VOLUME II
APPENDIX C
COMMENTS OF
THE S. W. SHATTUCK CHEMICAL COMPANY, INC.
ON THE
DENVER RADIUM SITE OPERABLE UNIT VIII

**Preliminary
Environmental Audit**

Envirocare of Utah, Inc.
Tooele County, Utah

Project No. D0297
May 1991

DISPOSAL CELL SEQUENCE

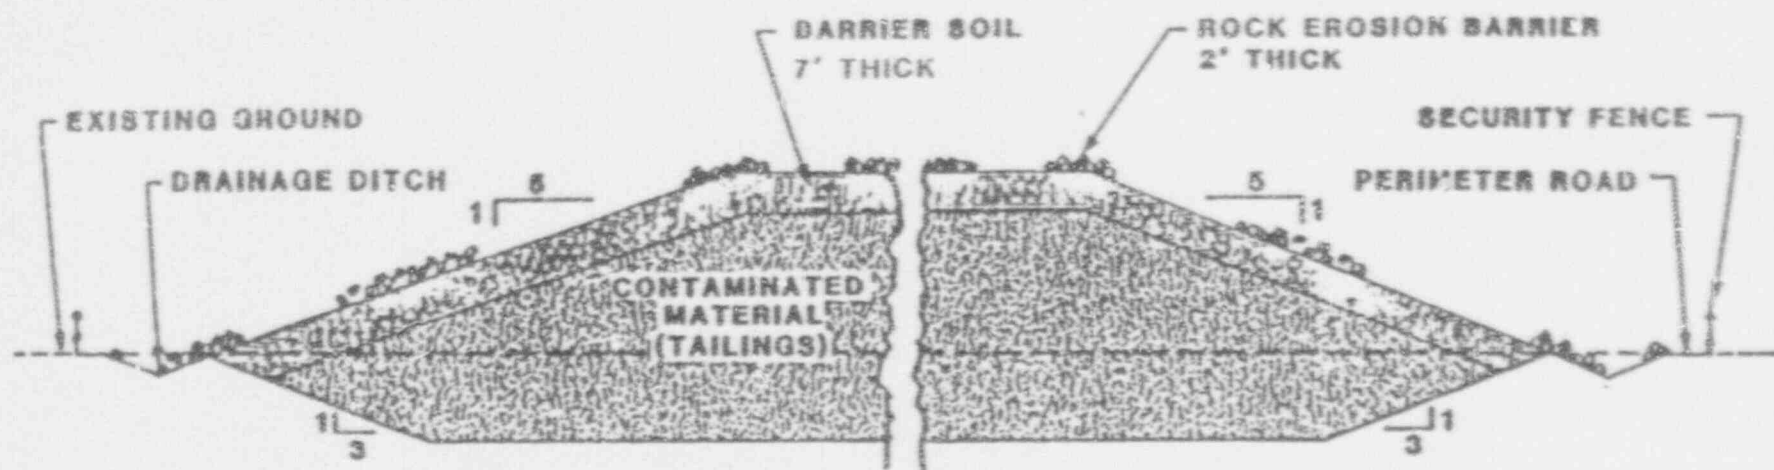
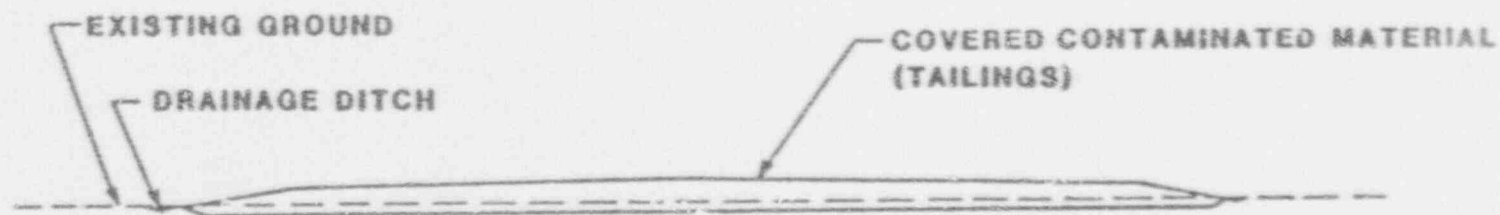
Page 3/3 in Appendix A illustrates Envirocare's typical design section for the NORM waste disposal cell concept. This concept is very similar to the design concept used for the Vitro disposal site and does not incorporate a bottom clay or synthetic liner, or leachate collection system. Essentially, 9 feet of natural silty/clayey soil are excavated to create a depression below the current ground surface. The soil removed from the excavation is stockpiled for later use as cover material during cell closure. The sandy unit in the bottom of the depression is scarified (loosened using a bulldozer equipped with a ripping blade) to a depth of 12 inches. Then it is compacted to 95 percent Standard Proctor density in conformance with the American Society for Testing and Materials Method D 698. This procedure forms the foundation of the disposal cell. NORM-contaminated soil or debris is placed in 12-inch lifts and compacted. Photographs of the facility taken during the site reconnaissance are presented in Appendix E. These include views of the embankment under construction.

quality issues, the soil used for the Vitro and NORM facilities' compacted cover should be evaluated further for its performance as impervious long-term cap material. Specifically, we could not find any information in either the Envirocare NORM application or the FEIS regarding (a) measurements of permeability versus degree of compaction or (b) shrink/swell potential determinations and believe both considerations warrant further assessment. A review of U. S. Department of Agriculture, Soil Conservation Service mapping information indicates that the soil type mapped at the Envirocare location has shrink/swell characteristics that may be of concern. This suggests that the compacted silty/clayey cover exposed directly to the ambient environment could potentially generate fractures in response to drying. If fractures develop, they could serve as preferred paths along which water could enter the waste and radon gas could exit.

MONITORING WELL LOCATIONS

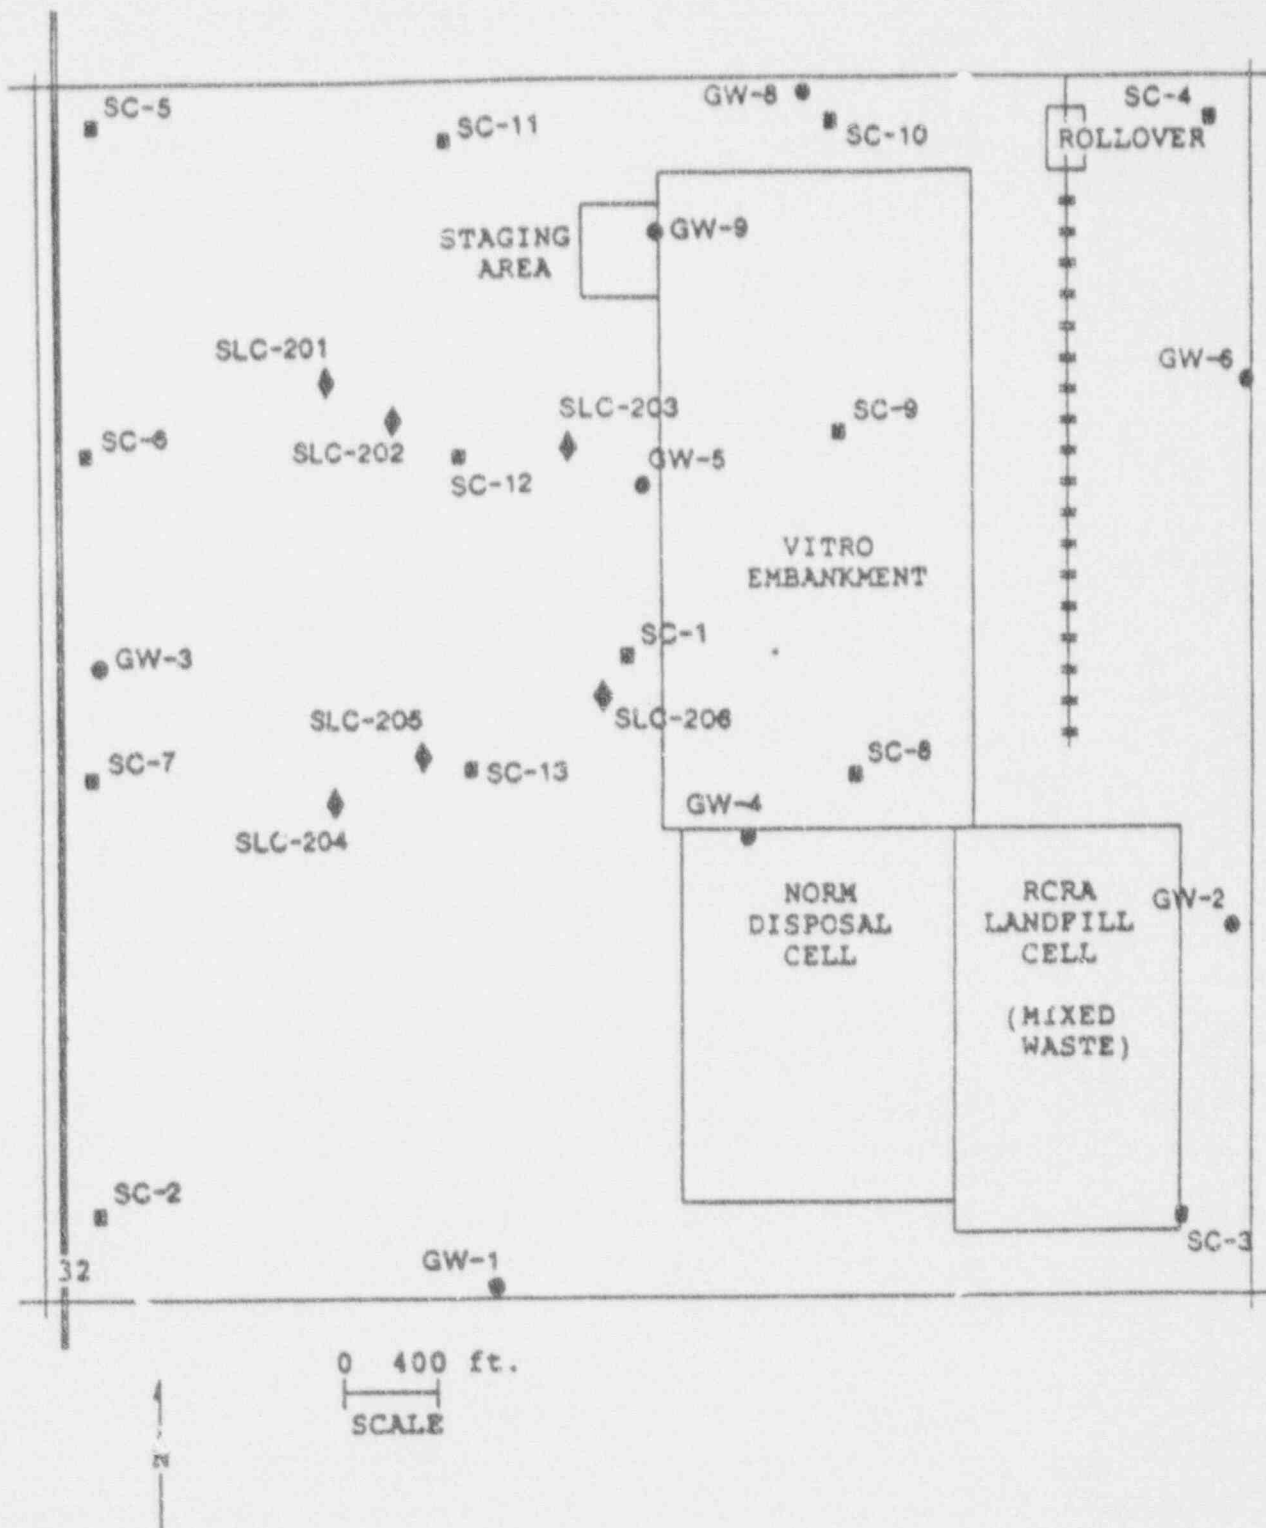
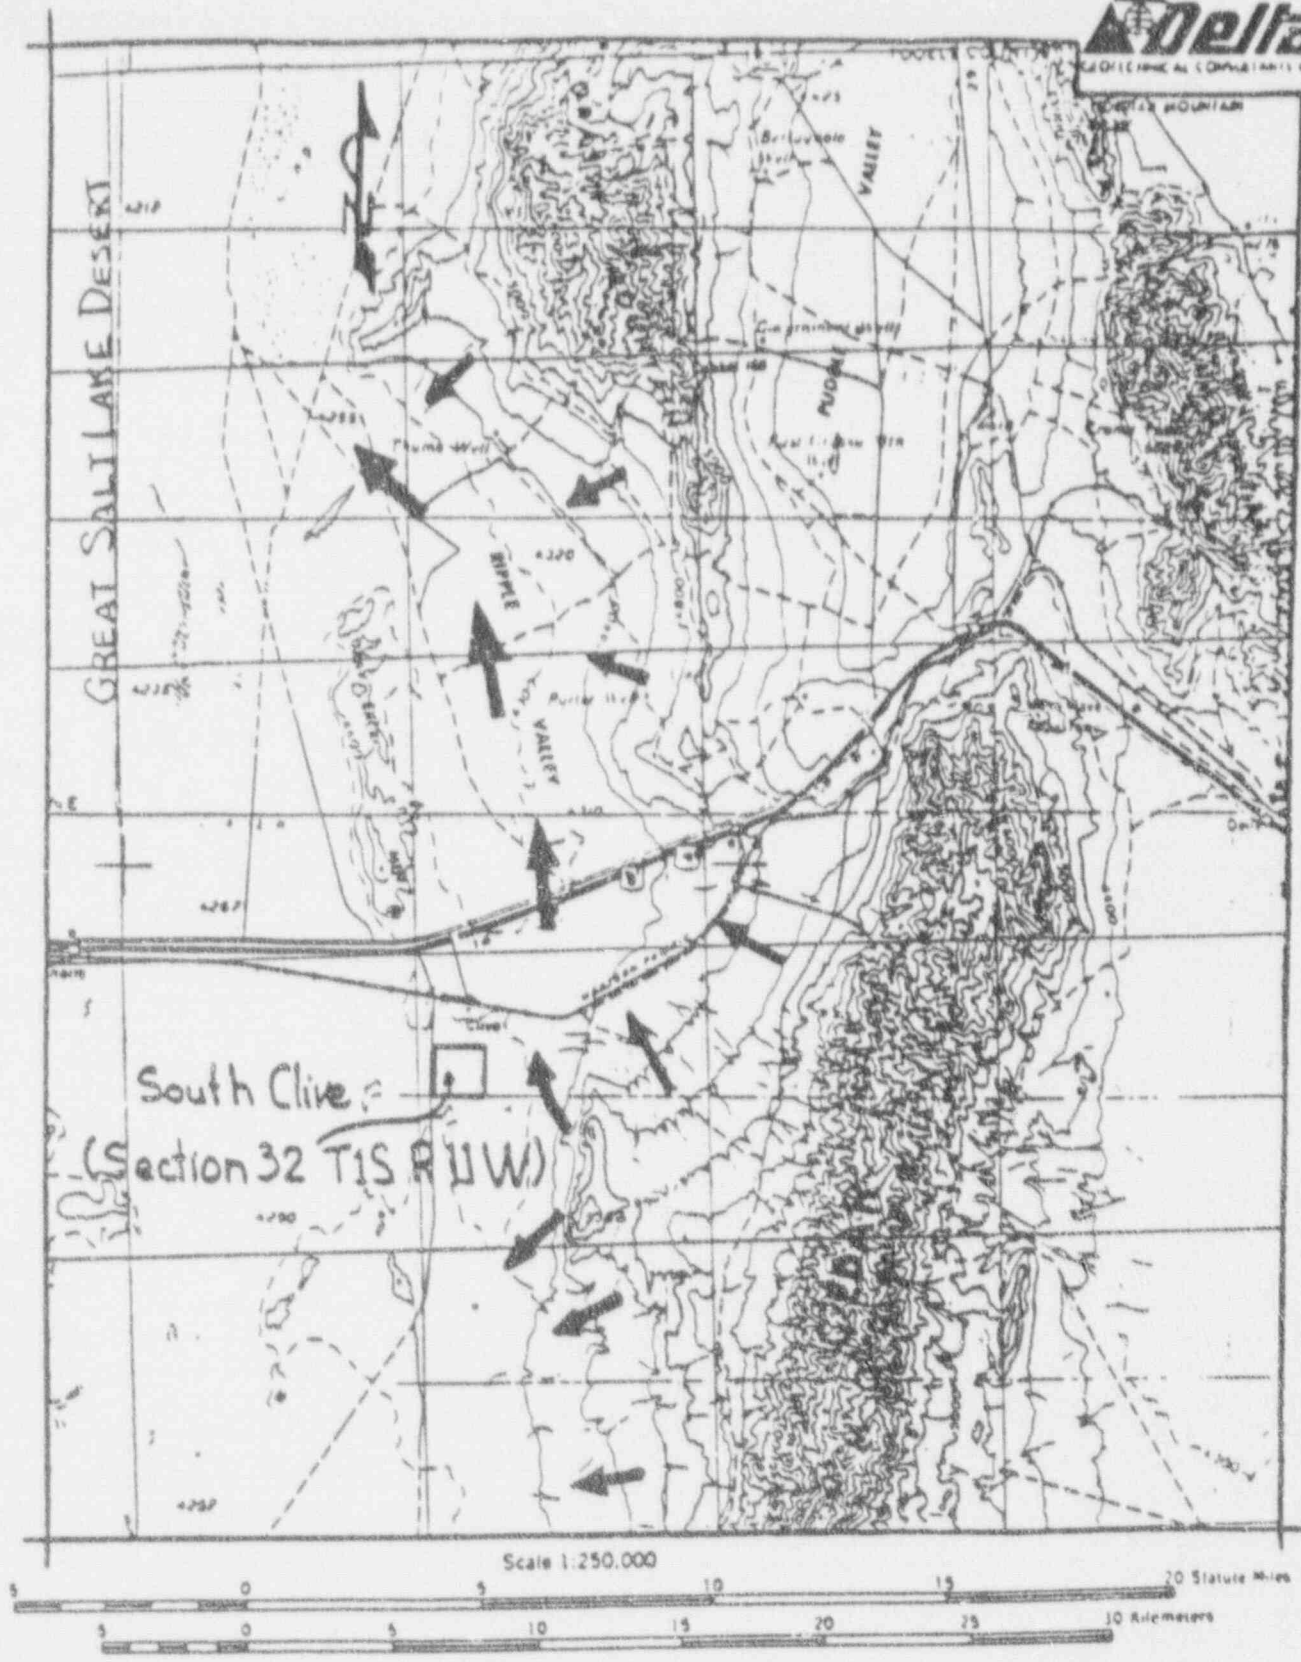
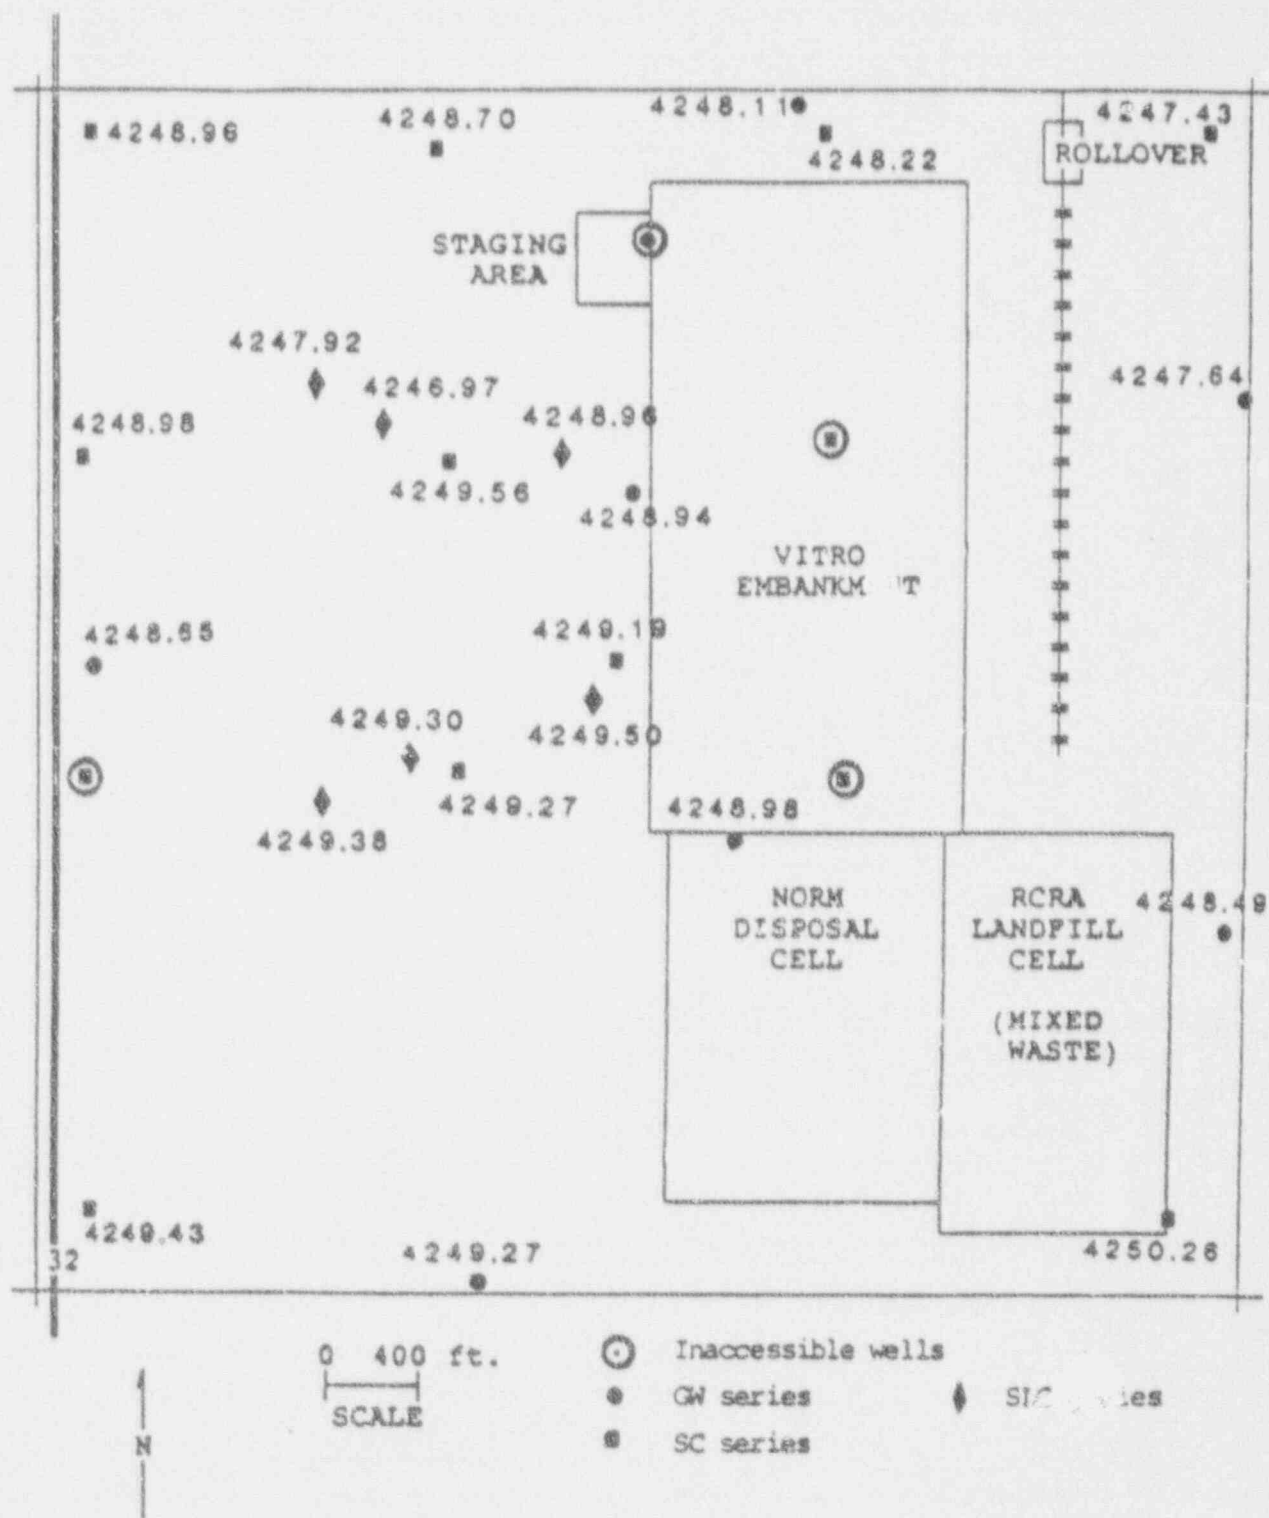
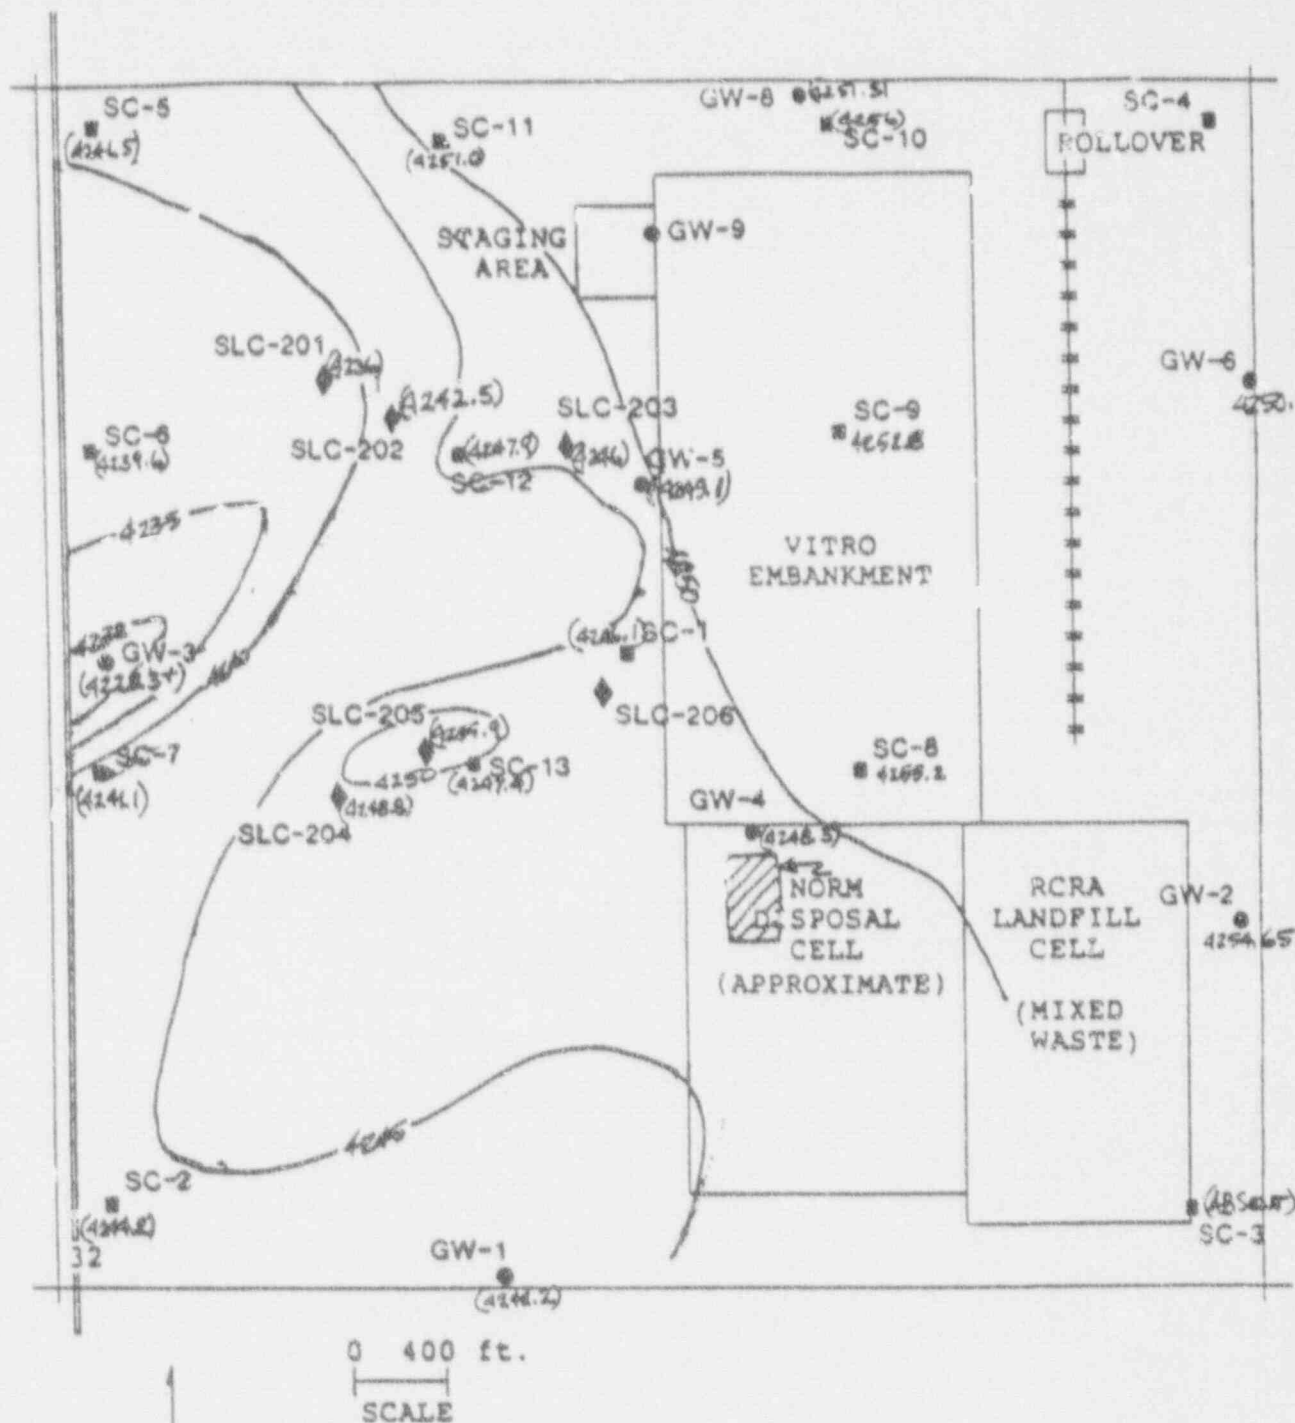
The letter transmitting Delta's report depicts the hydrogeologic conditions as well characterized by data obtained from existing reports and ongoing measurements of depth to water. Figure 1 (Figure 5 from the Delta report) shows the monitoring well locations and designations at the time of the report. In their transmittal letter, Delta cites that a "general northerly trend in flow direction is evident." This flow direction is portrayed in Figure 2 (Figure 7 from the Delta report). Our review of the information presented in Delta's report and other available references on the area (1) could not reach a similar conclusion regarding groundwater flow direction, and (2) suggests that hydrogeologic conditions are not well characterized by existing information.

The water elevation in all accessible monitoring wells was surveyed as part of Delta's investigation. These water level measurements are presented in Figure 3 (Figure 6 from the Delta report). Our review of Figure 3 suggests that no flow direction trend is apparent from these data, a conclusion shared by Delta's investigators. The groundwater flow direction is controlled by the hydraulic gradient (the slope of the water table surface). To determine the hydraulic gradient in a particular hydrostratigraphic unit, monitoring wells should be completed only in that unit. Since many of Envirocare's monitoring wells are screened in more than one hydrostratigraphic unit, the resulting water level

Based on our understanding of the disposal operation and local hydrostratigraphic conditions, seepage from the NORM-waste disposal embankment would enter the sand unit, migrate downward until it met a less permeable layer, and then flow laterally along that layer. The sand unit is underlain by a silty clay unit that is several orders of magnitude less permeable. Using boring logs and well completion records for the existing monitoring wells, we contoured the elevations of the base of the sand unit (Figure 4). The surface of the silty clay unit slopes in a west-southwestern direction. Since the sand unit is locally above the water table, seepage infiltrating from the embankment would be controlled to some extent by the top of the less permeable silty clay surface beneath the sand unit. Flow along this surface would be in a west-southwestern direction. Again, neither Envirocare nor Delta address this flow direction.

A review of Figure 5 (Figure 8 from the Delta report) shows the placement of existing monitoring wells plus the new wells proposed by Delta to monitor the mixed waste embankment. Few monitoring wells exist west or southwest of either the NORM- or mixed-waste disposal embankments. Considering that the groundwater flow direction is not well established, we believe the existing and proposed networks are deficient. Monitoring wells are required adjacent to the facilities on the west, southwest, and south to define the actual hydraulic gradient. Additionally, monitoring wells should be constructed in each hydrostratigraphic unit. Instead, more than one hydrostratigraphic unit is monitored by many existing wells and the existing and proposed monitoring wells are concentrated to the north, northeast, and northwest of the active NORM disposal operations.
